# memorandum

Subject: Hwy 546 Slope Failure  
Sta. 16+675 to 16+875  
Township of Nouvel  
W.O. 94-11002  
District 18, Sault Ste Marie

# HIGHWAY 546 FAILURE

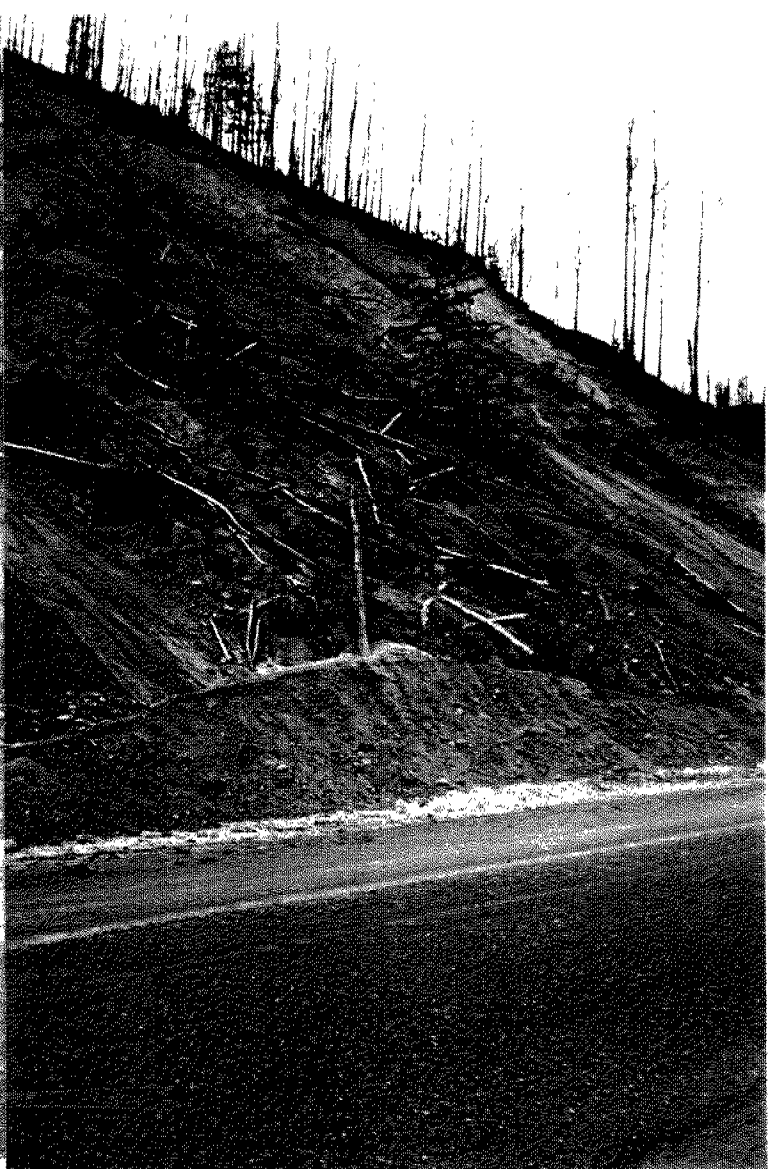
AREA WHERE  
WASHOUTS CLOSE  
ROAD.
